PD Modification Application: PD 25-0582
Zoning Hearing Master Date: December 15, 2025
BOCC Land Use Meeting Date: February 10, 2026

Development Services Department

1.0 APPLICATION SUMMARY

AGENCY REVIEW COMMENT SHEET

2.4 Proposed Site Plan (partial provided below for size and orientation purposes. See Section 8.2 for full site plan)

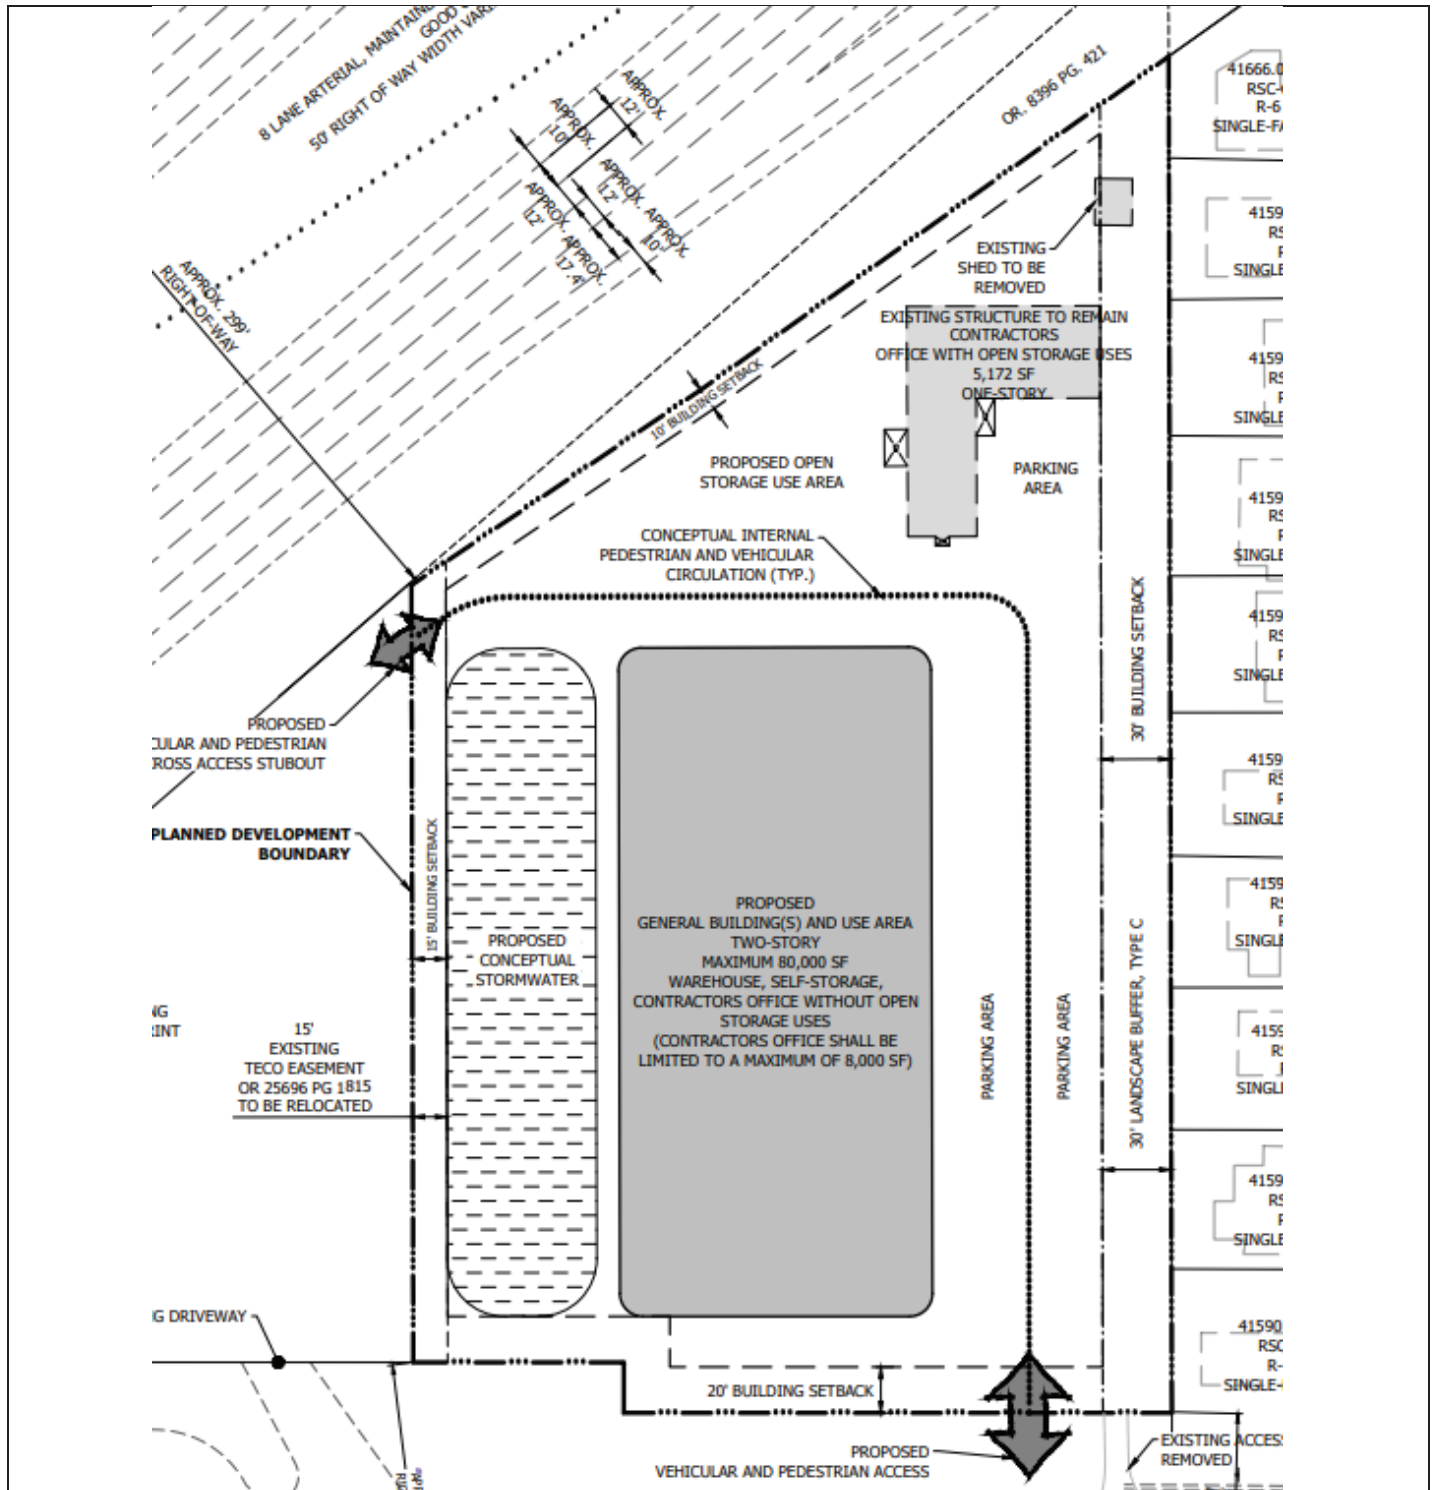
Approval of the request, subject to the conditions listed, is based on the revised general site plan submitted November 12, 2025.

2. Buildings shall be setback a minimum of 30 from the south (Chelsea Street), a minimum of 30 feet from the east, a minimum of 10 from the north, and a minimum of 15 feet from the west. Open Storage shall be permitted only west of the existing structure/contractor's office, as delineated on the site plan.

4. A 30-foot wide buffer with Type C screening shall be provided along the eastern PD boundary, as delineated on the site plan.
5. A six foot high solid PVC fence, solid wooden fence, or masonry wall shall be provided along the northern PD boundary.

8. The project shall be served by and limited to one (1) vehicular access connection to E. Chelsea St. All other existing connections shall be closed, with ditches and sod restored. Additionally, prior to or concurrent with the initial increment of development, the developer shall construct a vehicular and pedestrian cross access stubout along the project's western boundary, as shown on the PD site plan.

Connection Spacing Exhibit

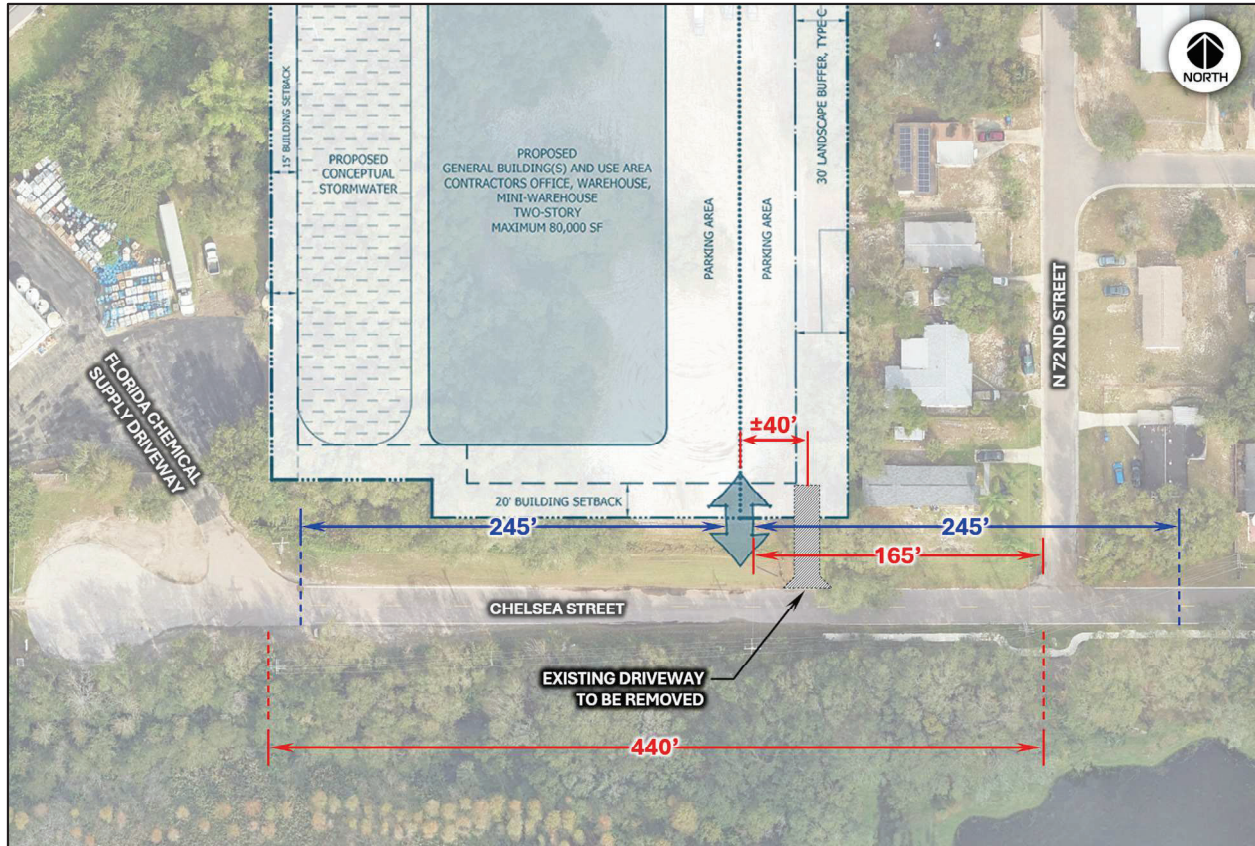
In consideration that Chelsea Street is a collector roadway, the applicable minimum connection spacing criteria is identified as 245 feet pursuant to LDC §6.04.07 for an Access Class 6 facility (for posted speeds ≤ 45 mph). Within 245 feet from the location of the planned (relocated) site access driveway connection to Chelsea Street there is one existing connection. The referenced existing connection (N 72nd Street) is located ± 165 feet east of the planned project site driveway, on the north side of Chelsea Street; as shown in **ATTACHMENT C**.

THERE IS AN UNREASONABLE BURDEN ON THE APPLICANT The project site has approximately 330 feet of frontage along Chelsea Street, therefore, a conforming site access driveway connection to Chelsea Street cannot be accommodated, as the distance between the next westerly connection (Florida Chemical Supply Driveway) and the next easterly connection (N 72nd Street) is only ± 440 feet. Shifting the site access driveway connection to the west to increase the spacing from N 72nd Street would result in non-conforming connection spacing to the west, and would conflict with the planned building envelop and stormwater pond for the site. Therefore, approval of this Administrative Variance is necessary such that an unreasonable burden is not unduly imparted upon the applicant.

WITHOUT THE ADMINISTRATIVE VARIANCE, REASONABLE ACCESS CANNOT BE PROVIDED The subject planned site access driveway connection to Chelsea Street cannot be located in conformance with the applicable connection spacing requirements, and the project site does not have frontage along any other roadways. Therefore, the subject driveway connection to Chelsea Street is necessary to provide reasonable access to the external roadway network. Therefore, approval of this Administrative Variance is necessary to provide reasonable access for the subject project.

The applicant's Engineer of Record (EOR) submitted a Sec. 6.04.02.B. Administrative Variance (dated December 3, 2025) from the Sec. 6.04.07 LDC requirement, governing the project's E. Chelsea St. access spacing. The Hillsborough County LDC requires a minimum connection spacing of 245 feet for a Class 6 roadway with a posted speed of 45 miles per hour or less. This segment of E. Chelsea St. has a posted speed of 25 mph in the vicinity of the proposed project. The applicant is seeking a variance of +/- 80 feet from the closest driveway to the east on the same side of the roadway, such that the developer will be permitted to construct the project access in a location +/- 165 feet from that driveway. The request was found approvable by the County Engineer (on December 5, 2025).

If PD 25-0582 is approved by the Hillsborough County BOCC, the County Engineer will approve the Administrative Variance.

I have found the attached Section 6.04.02.B. Administrative Variance (AV) and Design Exception (DE) for PD 25-0582 APPROVABLE.

Hillsborough County TS-7 Typical Section

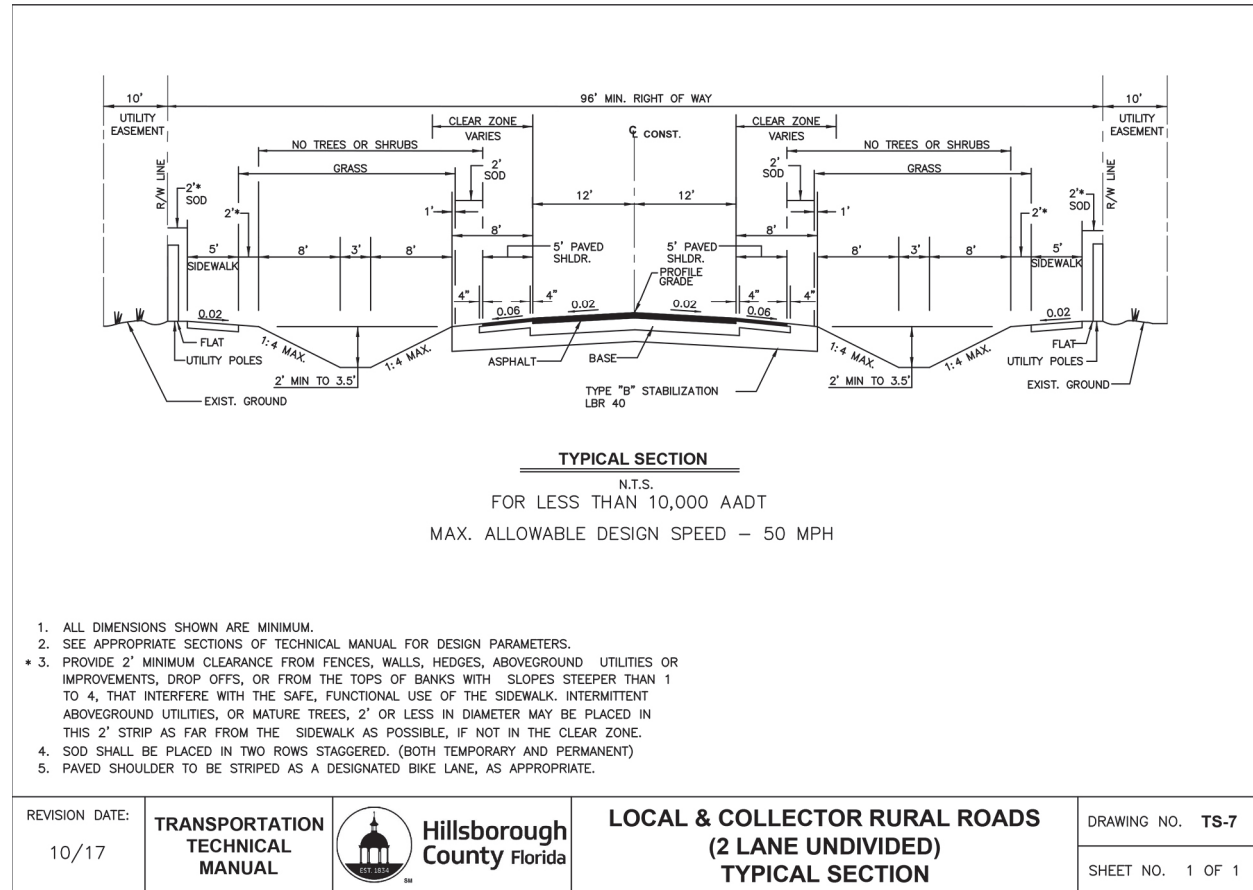
As E. Chelsea St. is a substandard collector roadway, the applicant's Engineer of Record (EOR) submitted a Design Exception request (December 3, 2025) to determine the specific improvements that would be required by the County Engineer. Based on factors presented in the Design Exception request, the County Engineer found the request approvable (on December 5, 2025). The developer was not required to make any additional improvements not already required pursuant to Sec. 6.03.02 of the LDC. The Design authorized deviations from the type TS-7 (Typical Section – 7, for 2-lane Rural Local and Collector Roadways) of the TTM. Specifically:

1. The developer shall be permitted to maintain the 10-foot-wide travel lanes in lieu of the 12-foot-wide travel lanes required by TS-7;
2. The developer shall be permitted to leave the existing unpaved shoulders in their current condition, rather than the 8-foot-wide stabilized shoulders, of which 5-feet is paved (and which provides for on -street bicycle facilities) required per TS-7;
3. The existing right-of-way is being permitted to remain in its existing state, in lieu of the 96 feet of right-of-way required per TS-7.

If PD 25-0582 is approved, the County Engineer will approve the Design Exception.
